Internal Framing
Of Cupola Columns

Looking West at East elevation

3.

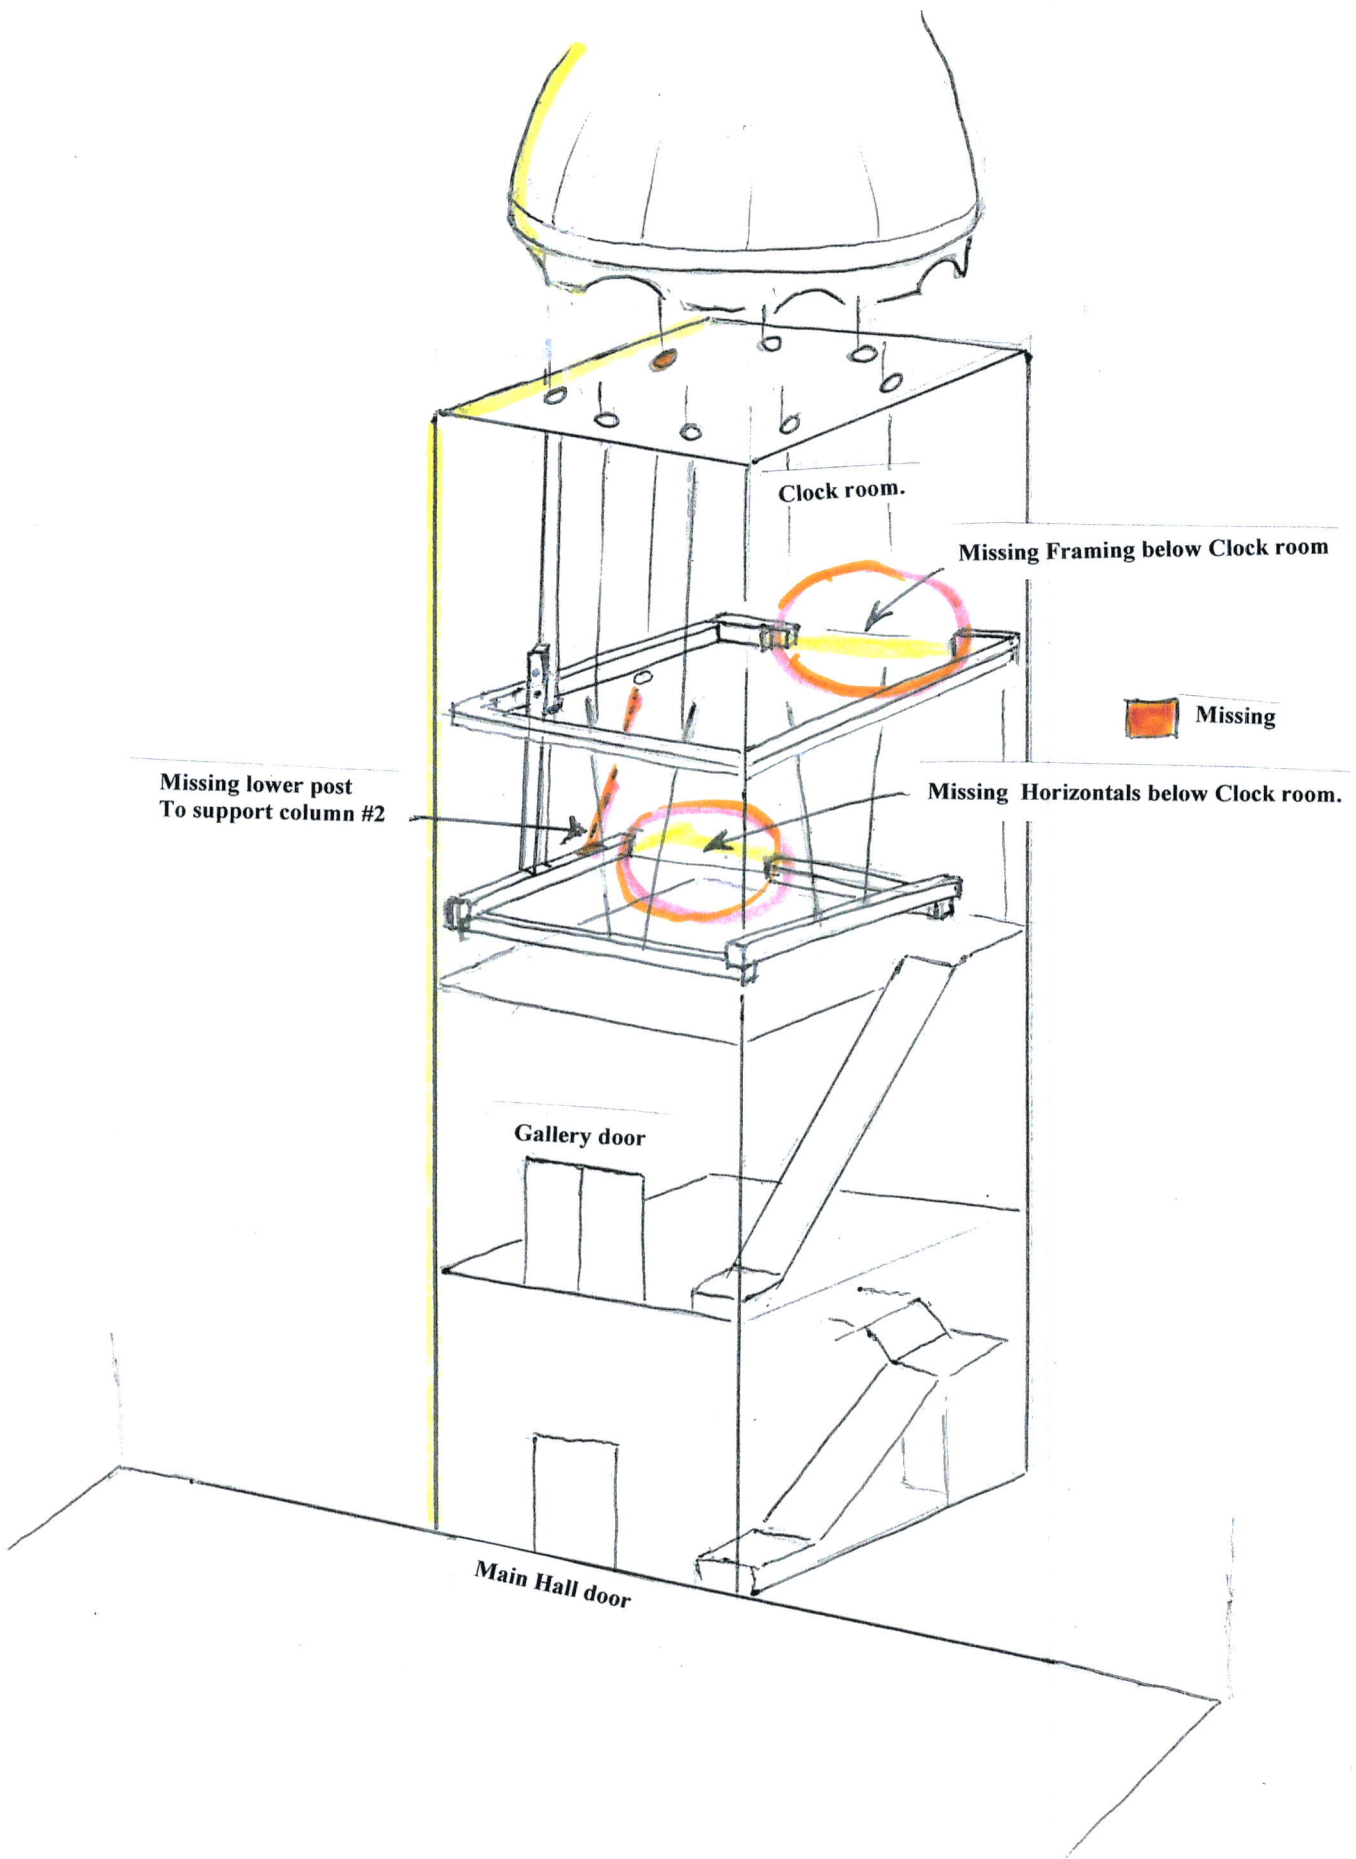
-  Recommend replacement
-  Rotten
Needs replacement
-  Suspect
-  Needs replacement

Clock room.

5.

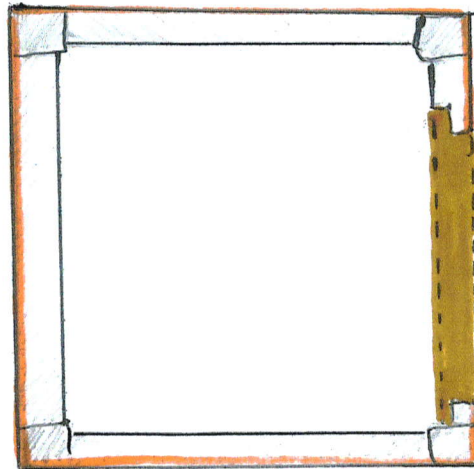
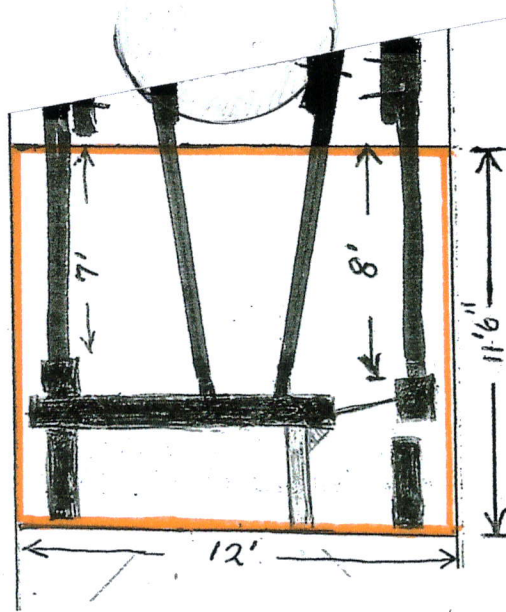
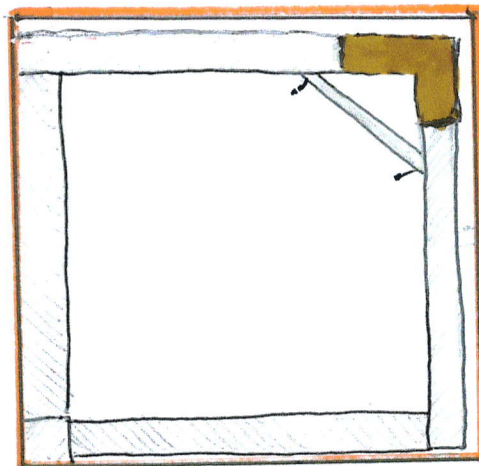
Missing Framing below Clock room

Missing horizontals

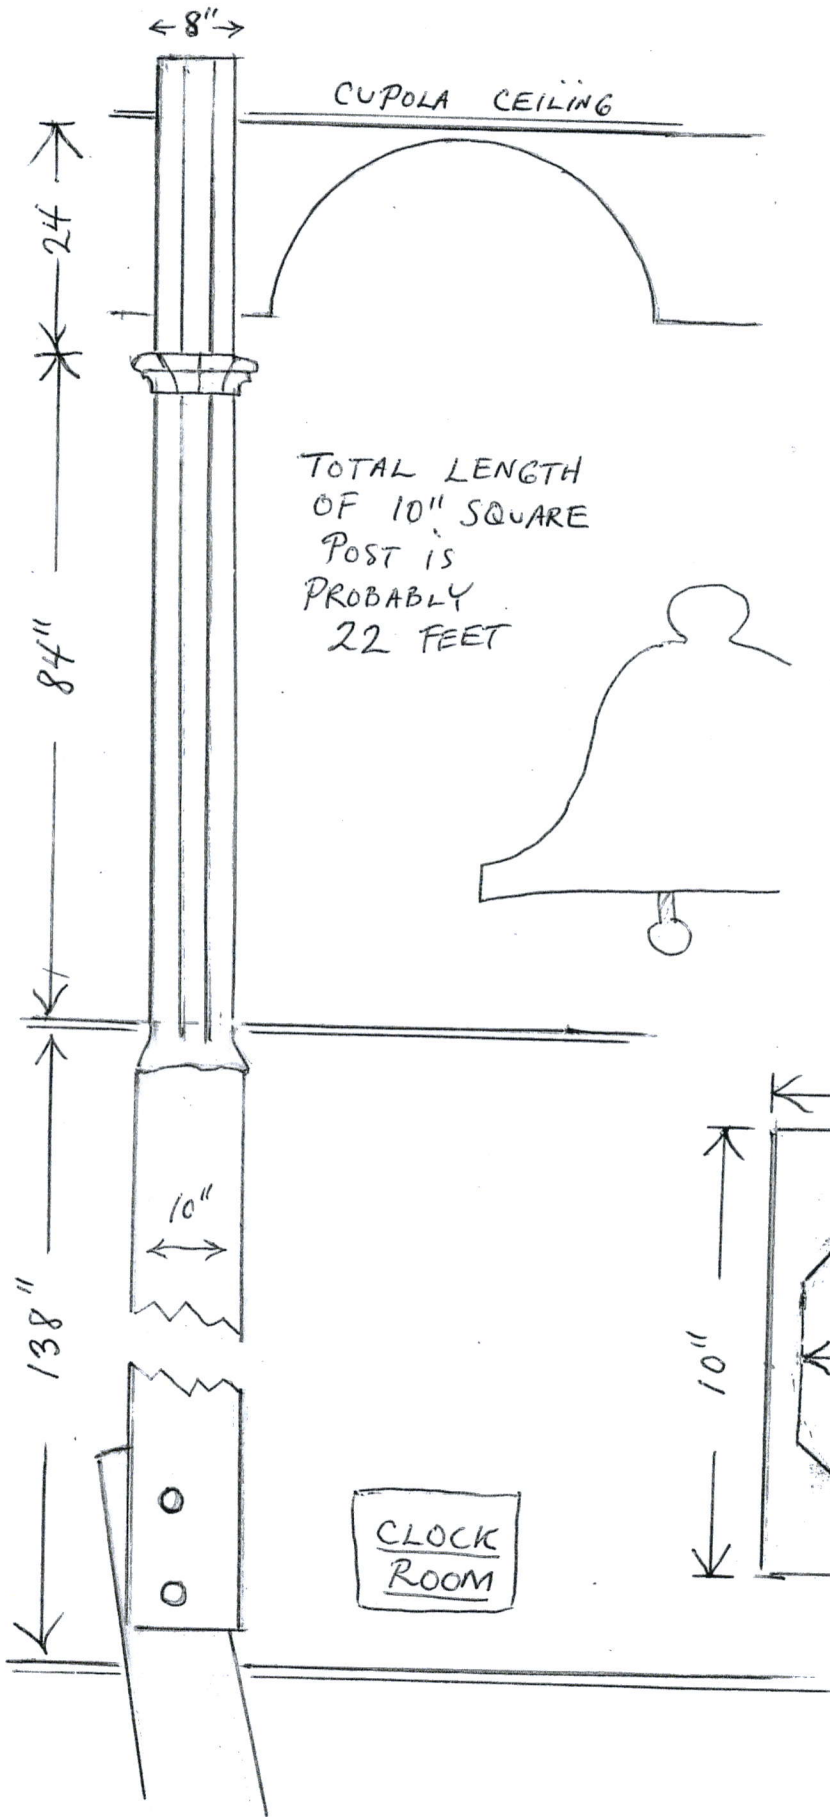
Repair beneath East clock room floor needing replacement. Provides little or no actual support to the structure.

Missing 6x12" supports to lower cupola columns due to 1893 clock installation.

OCTAGONAL POST CUT FROM 10" SQUARE POST.
